CC-0010 Sandy Springs Phase II Update

November 1, 2016

Sandy Springs Circle Sidewalk
from Hammond Drive to Mt. Vernon
City of Sandy Springs
GDOT PI No. 0010385

Approved City Springs Master Plan Typical Section Sandy Springs Circle (Mt Vernon to Hammond Dr) December 2012

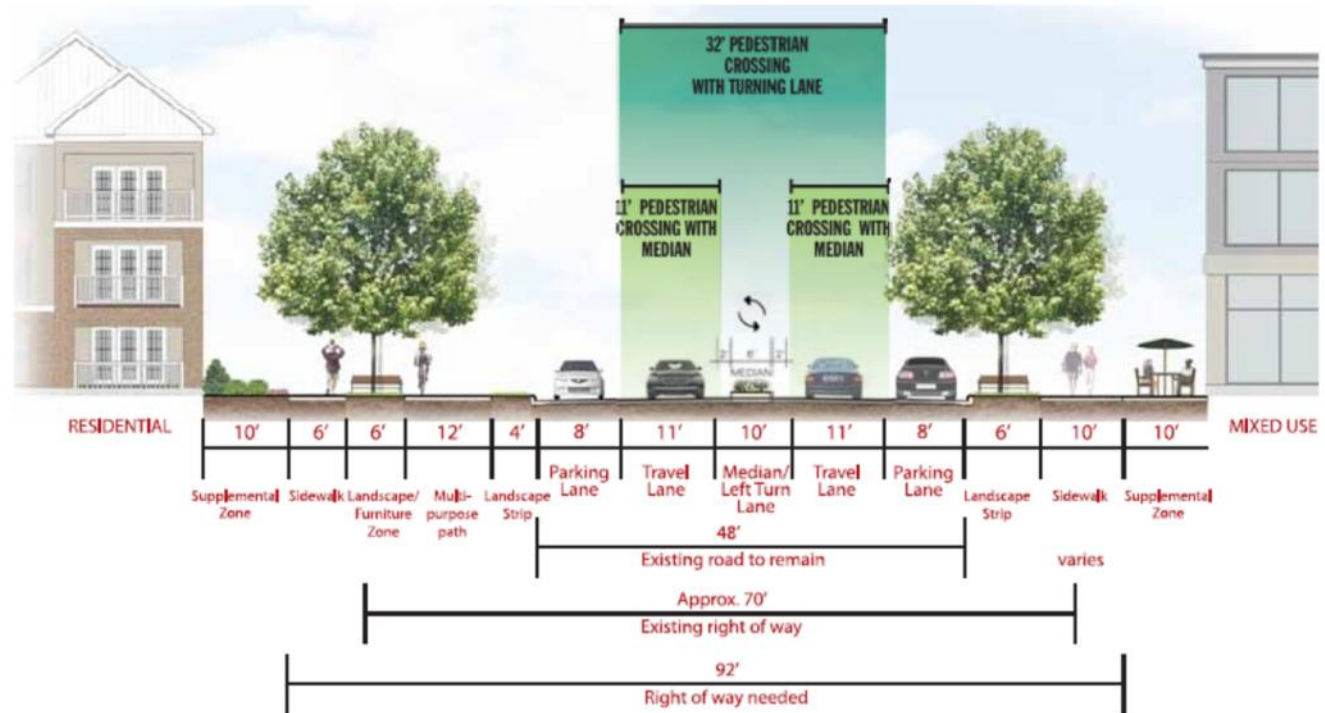
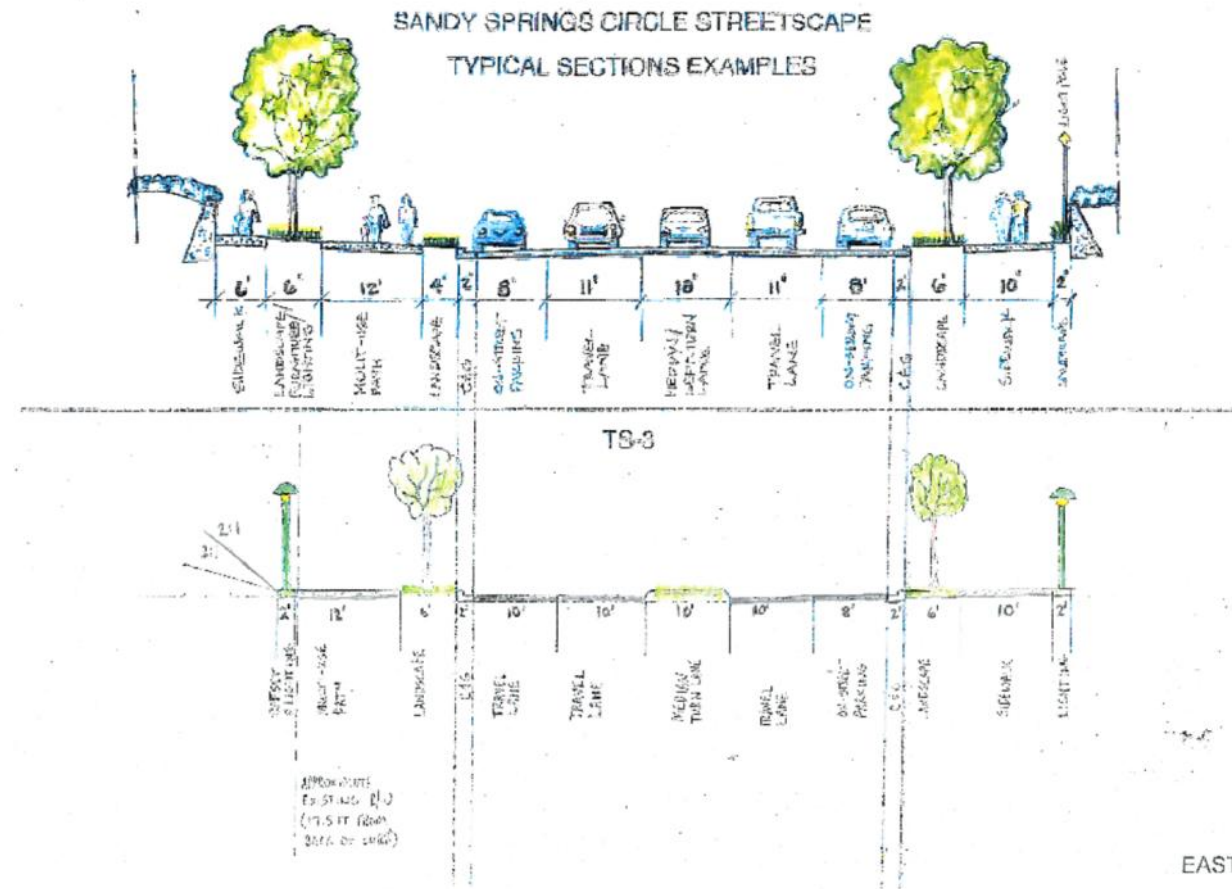
- Right of way acquisition from the original design impacting the SSUMC
- On street parking
- Driveway location to Hitson Center
- Size of retaining wall
- Travel lane reduction

- Reducing right of way acquisition
- Reduce travel lanes to 10' wide from 11ft
- Eliminate parallel parking on western side of road and convert to travel lane
- Eliminate landscape furniture zone
- Eliminate 6ft wide sidewalk
- Reducing the need for retaining walls along SSUMC
